1 Products affected

Product hierarchy no. *				Part no.	SBU	Type / Description	Customer part no.
SBU	PG	PUG	Type				
02	005	116	0000001168	See list below	Power entry module	DD21

2 Type of change

Change of rating marks on the product.

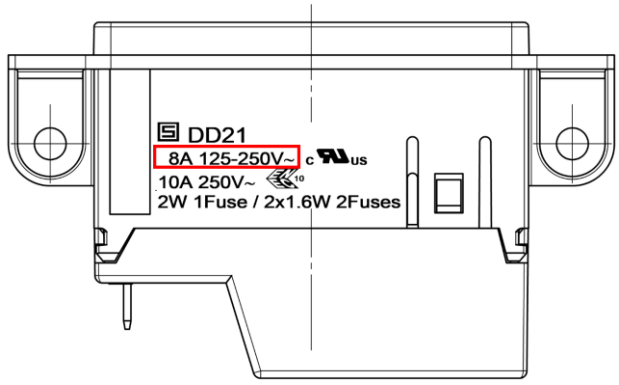
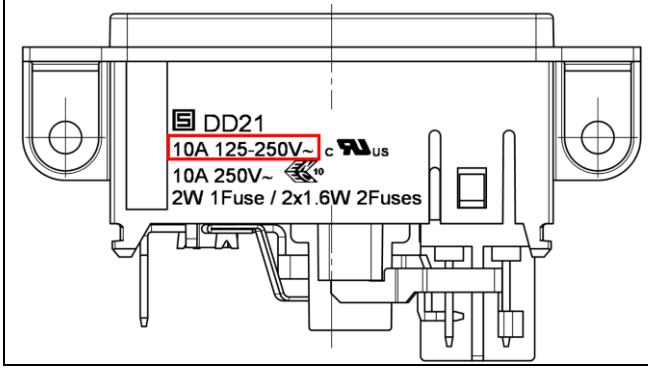
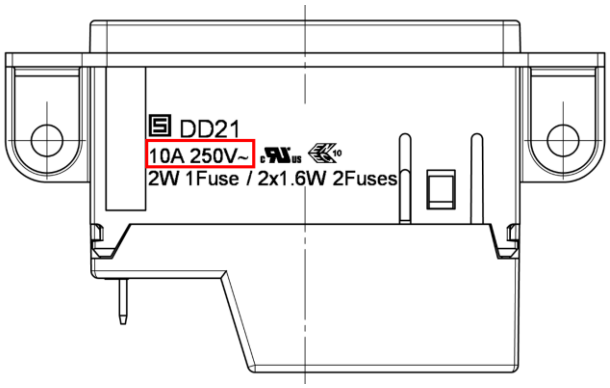
Old product rating	New product rating
With cover  Without cover  	With or without cover

Standards update according to the new UL/CSA 60320-1.
